Work Order ID 64160 Page 1 Thursday, November 25, 2010 4:01:52 PM Accept Item ID: D4298-008 Setup Start **Revision ID: PRELIM** Stop Plate **Item Name:** Start Qty: 1.00 Start Date: 11/25/2010 **Cust Item ID: Required Date: 12/3/2010** Req'd Qty: 1.00 POSITIVE RECALL **Customer:** Reference: Start Run Date: /0//-2/ Tooling: **Process Plan:** Approvals: Date: Stop QC: Date: SPC (Y/N): Date: Sequence ID/ Operation Set Up/ **Tool ID** Tool # Plan Accept Reject Reject Insp. Description Work Center ID Qty Code **Run Hours Qty** Number Stamp **Draw Nbr Revision Nbr** D4298 PA1 100 0.00 FLOW WATER JET B10-11-36 Waterjet 0.00 Memo BUO-10-3 FLOW CNC Waterjet 1-Cut as per Dwg Dwg Rev. DA 1310-12-9 6061.080 Prog Rev: 2-Deburr if nedessary 110. QC2- Inspect parts off machine FAI/FAIB 0.00 B10-11-30 QC 0.00 Memo B10-17-3 Quality Control . 1B10-12-9 120 QC8- Inspect parts - second check Memo Quality Control

DART AEROSPACE LTD	Work Order:	64160 1
Description: PLATE	Part Number:	D4368-008
Inspection Dwg: D4398-00%, Rev: PRELZ		Page 1 of 1

Α	NEW ISSUE			SC	10.12.15		
REV.			DESCRIPTION	BY	DATE		
DESIGN SC		SC	DART AEROSPACE LTD				
DRAWN		SC	HAWKESBURY, ONTARIO, CANADA				
CHECKED W)		7	DRAWING N

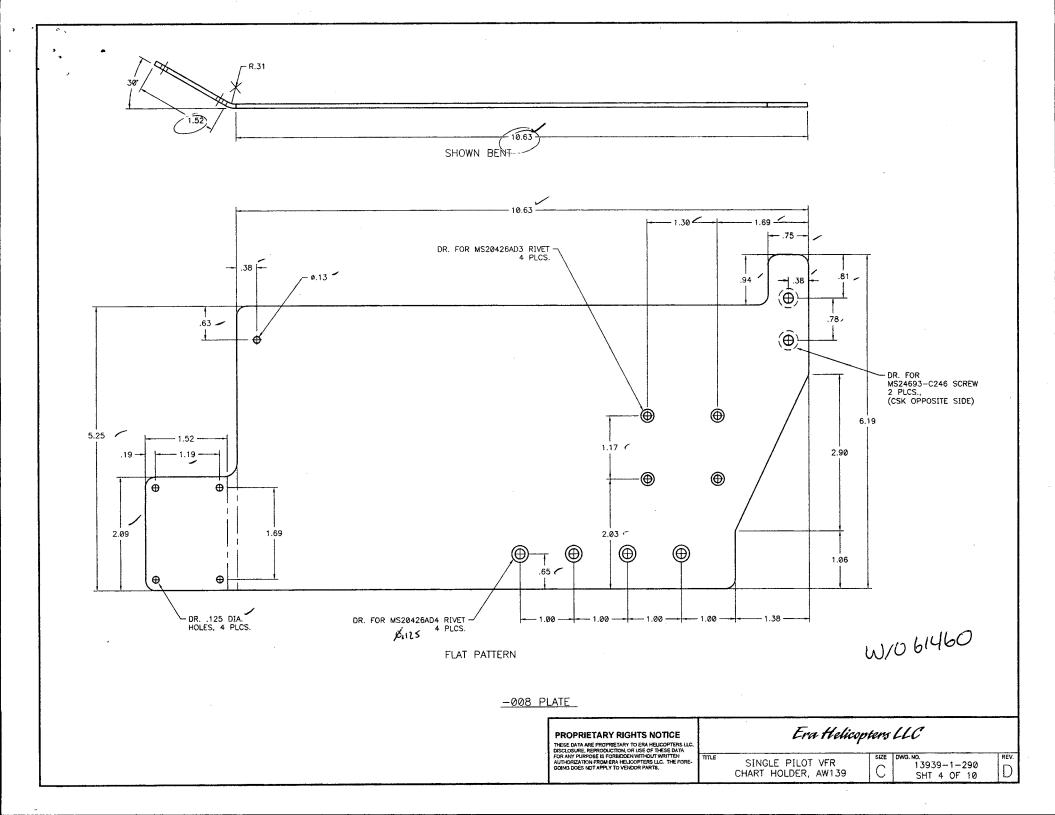
Hi David, we are starting to produce parts for the "Chart Holder", shop support as come to me with the following problem please read e-mail below and let me know what we need to do with this.

There is something funky with part in subject line.

Sylvie performed the bend using the 1.62" dimension and came to see me with something that "looks" like the drawing (see attached). So I am thinking that either the flat pattern was changed without any update on the drawing or the flat pattern is wrong. Basically, the bend should be located at 10.56" from edge as shown on drawing, with 1.62" long portion of sheet bent upward at 30 degrees. We can't achieve this with the flat pattern we have and I am not in a

Eric, the drawings were in error. The start of the bend should have been located 10.63" from the edge, not 10.56", on the main drawing. The straight part after the 30 degree bend is 1.52" long. The bend radius is .31". I'm attaching a revised version of the drawing with the corrections, plus the DXF flat pattern.
